14 March 2023

Re: oLiv Sound Isolation Study Phase 2 (Revision)  
Madison, WI  
KN° 3243

### “Better” Recommended Ceiling

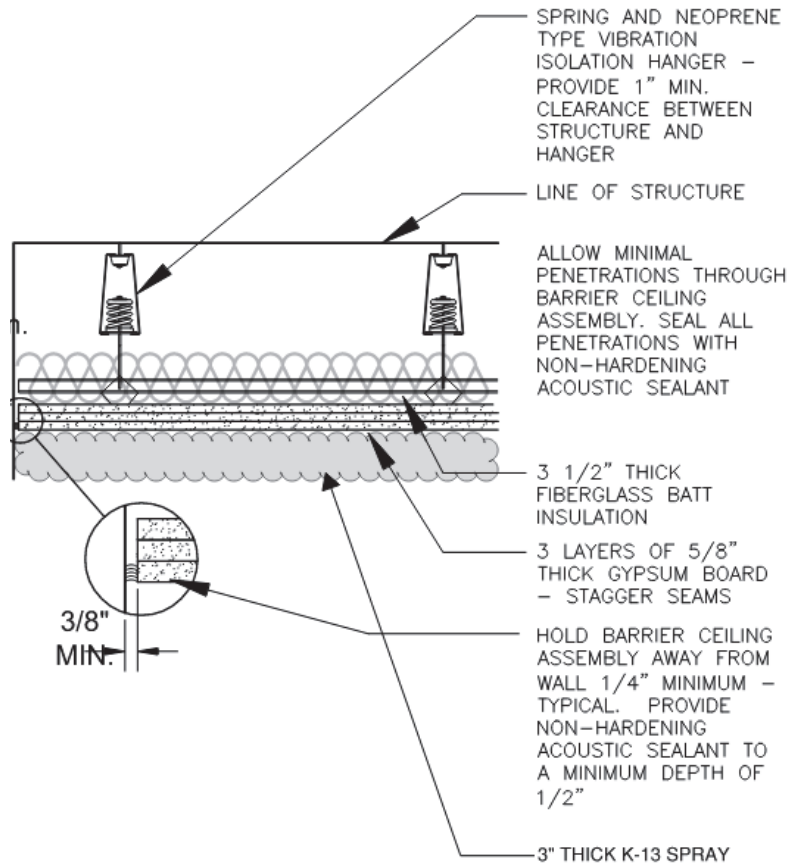
- Gypsum Board Barrier Ceiling
- 3 layers 5/8" gypsum board, hung from bottom of structure with spring and neoprene isolators.
- 3" thick batt insulation resting above gypsum board.
- Seal perimeter airtight with acoustic sealant.
- Minimum 14" airspace between barrier ceiling and bottom of structure.
- MEP serving the first floor should all be located and routed below the barrier ceiling to avoid penetrations through the gypsum board.
- Treat underside of gypsum board with minimum 80% of ceiling area of 3" thick K-13 spray for loudness control within room.

- Gypsum Board Barrier Ceiling

**“Best” Recommended Ceiling**

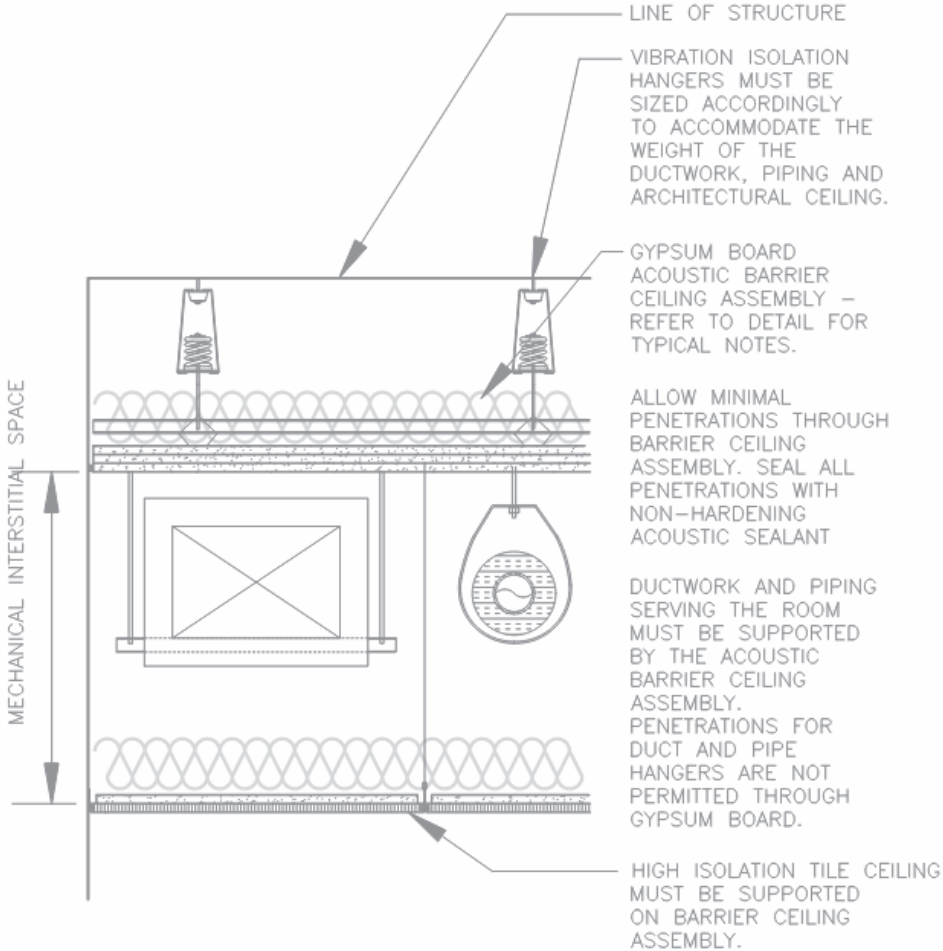
- ~~High Isolation Acoustic Ceiling Tile + Gypsum Board Barrier Ceiling~~
- ~~Gypsum board barrier ceiling as previously defined, hung minimum 14" below slab.~~
- ~~High isolation acoustic ceiling tile as previously defined, hung minimum 14" below barrier ceiling.~~
- ~~MEP serving the first floor should all be located and routed below the barrier ceiling to avoid penetrations through the gypsum board.~~

- ~~High Isolation Acoustic Ceiling Tile + Gypsum Board Barrier Ceiling~~

KIRKEGAARD RECOMMENDED CEILING TREATMENT EXTENTS

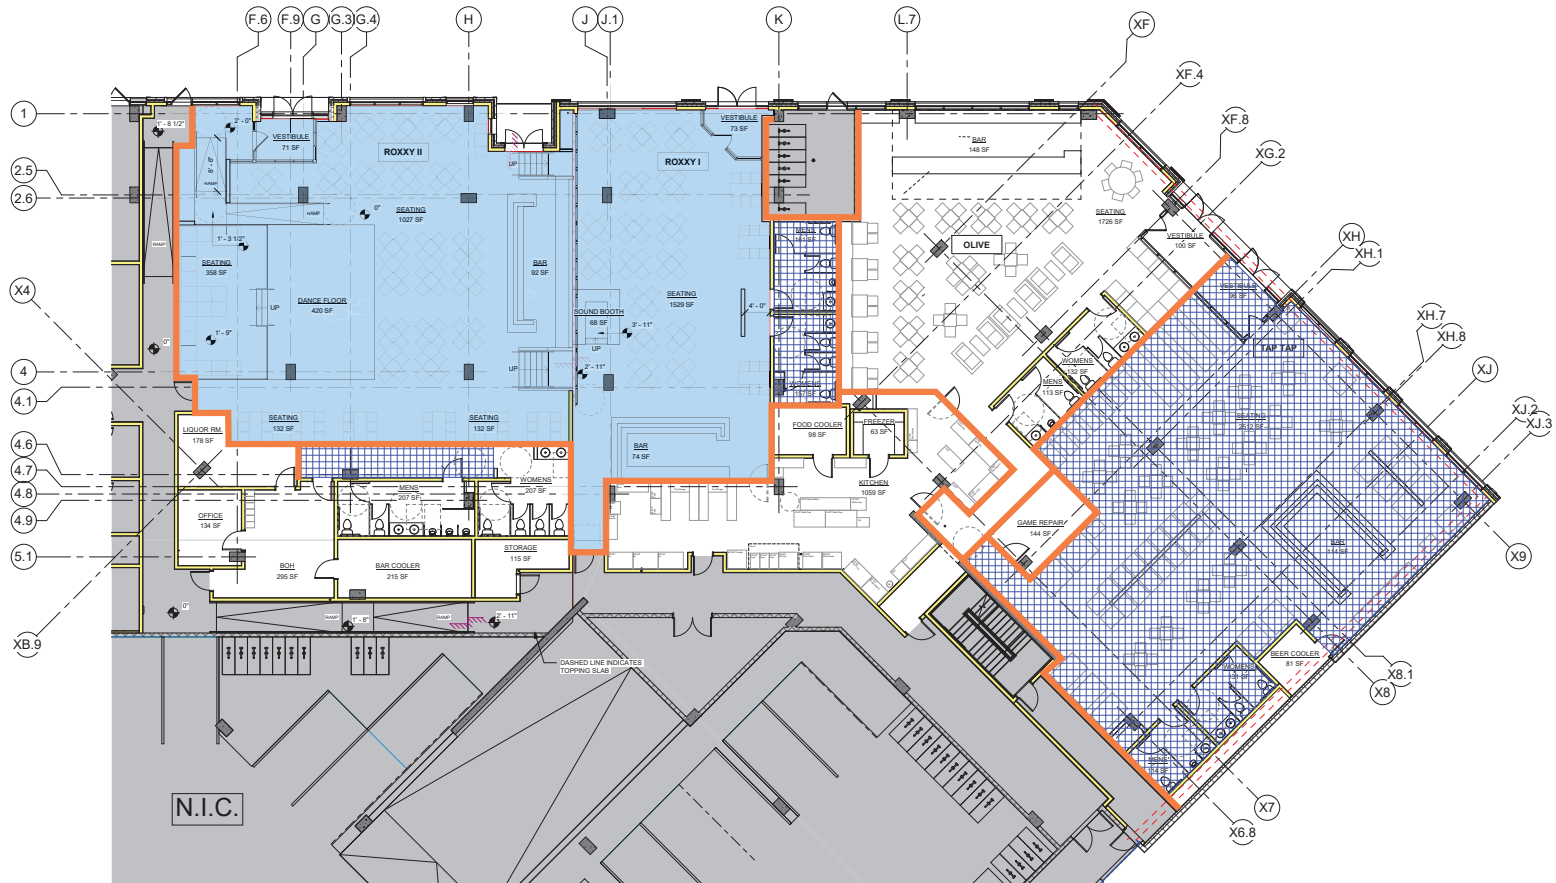
The attached markup of isolation treatment extents includes our minimum recommendation for full-height partitions (insulated, continuously sealed to structure with full perimeter gaskets on doors). Within these isolation partitions, the extent of the “Good” and “Better” ceiling recommendations are as follows.

We recommend the “Better” treatment should cover the entire ceiling above both Roxxy spaces. After further review from our previous discussions, there is greater overlap above than originally thought (see attached markup). The reason for including the barrier ceiling below the green roof is that it is difficult to predict how sound energy might energize the concrete slab and travel horizontally into 2<sup>nd</sup> floor units (bypassing the barrier ceiling).

If the entire ceiling area is not possible, the barrier ceiling must exist at minimum in the area 2’ beyond the perimeter of the residential unit footprints above Roxxy 1 and Roxxy 2. This area is indicated on the attached ceiling treatment markup. All layers of gypsum board of the barrier ceiling should continuously return to structure above and seal airtight with a soft joint. And at minimum, the rest of Roxxy and restroom corridor should have “good” ceiling type. If left untreated with only exposed slab, the noise traveling horizontally from the portion of exposed slab into 2<sup>nd</sup> floor units may be audible and somewhat loud at particular frequencies.

- "BETTER" GYP BD BARRIER CEILING
- "GOOD" HIGH ISOLATION ACT CEILING
- FULL-HEIGHT, INSULATED PARTITIONS CONTINUOUSLY SEALED TO STRUCTURE. DOORS REQUIRE FULL-PERIMETER GASKETING.
